**RE: USC Upstate Parking Lot Resurface & Repair
State Project # H34-I352
URS Project No. 46422372**

ADDENDUM NO. 1 – MAY 11, 2012

ADDENDUM #1 – SHT. C2

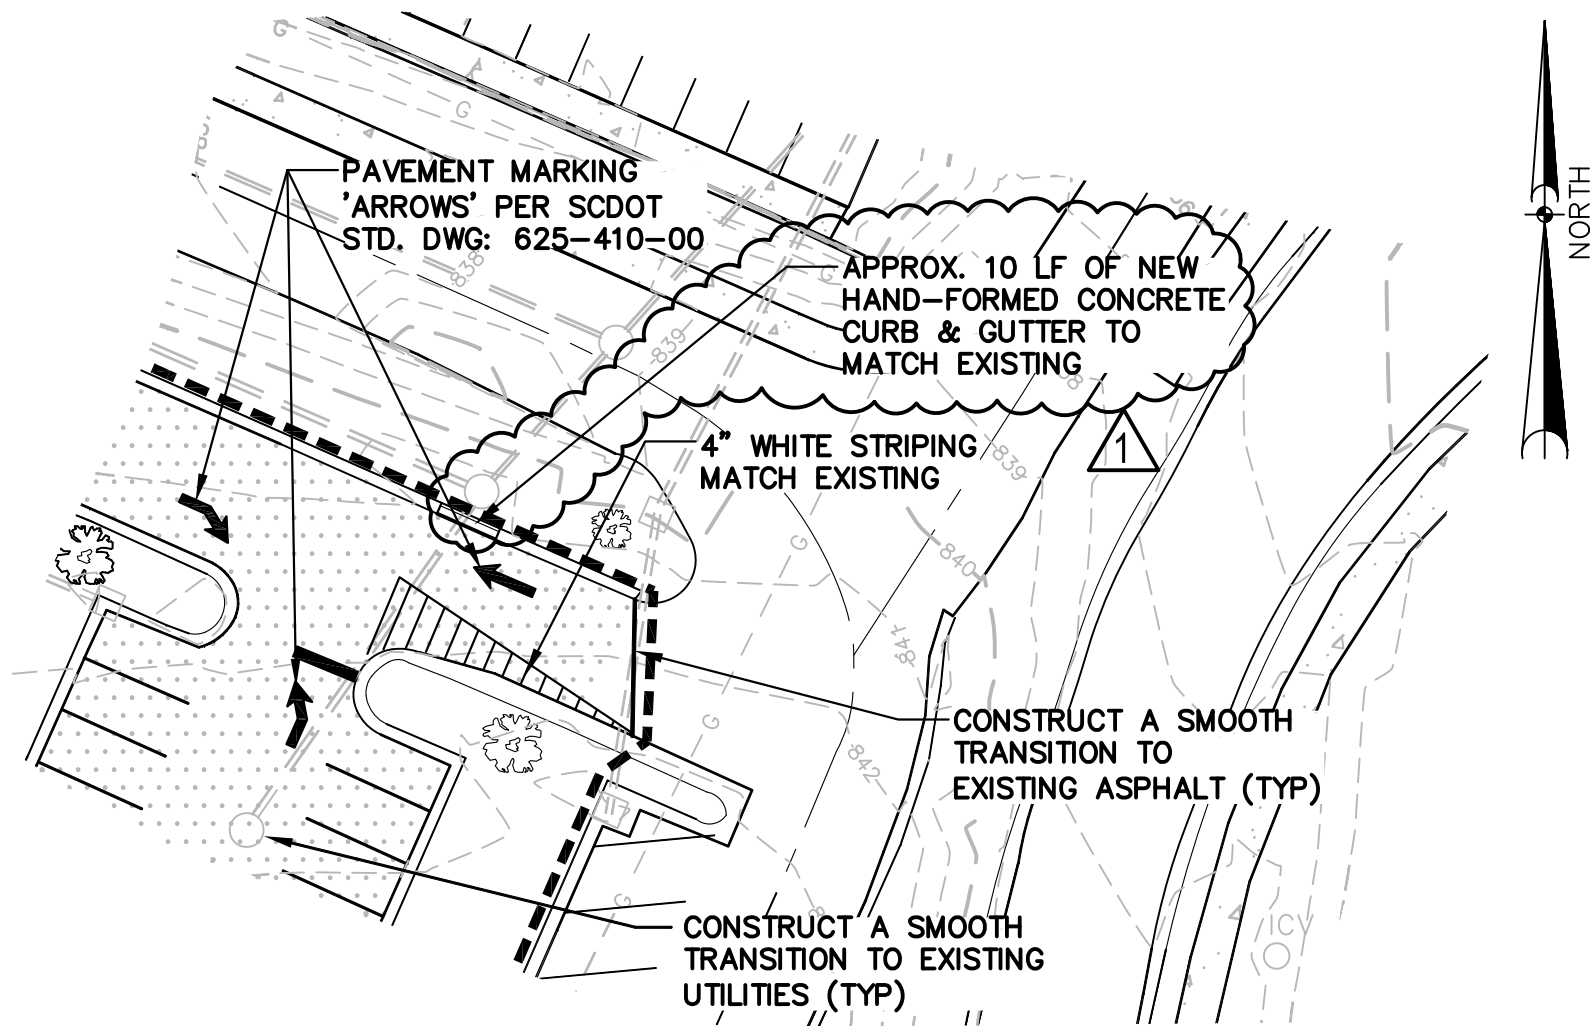
1. **Sheet 2 – Existing Conditions & Demolition Plan:** Demolish approximately 10 LF of damaged concrete curb and gutter in the North Lot and the approximate 4-ft x 5-ft asphalt ramp in the South Lot.
2. **Sheet 3 – Site Improvement Plan:** Install approximately 10 LF of hand-formed concrete curb and gutter in the North Lot and approximately 4-ft x 5-ft of full depth asphalt pavement patching at the former asphalt ramp location in the South Lot.
3. **Sheet 4 – Paving & Site Details:** Detail 3 allows for either asphalt aggregate base course or 6-in graded aggregate base course at 98% Standard Proctor. Detail 11 clarifies that a manhole ring and cover is part of the modified yard inlet.
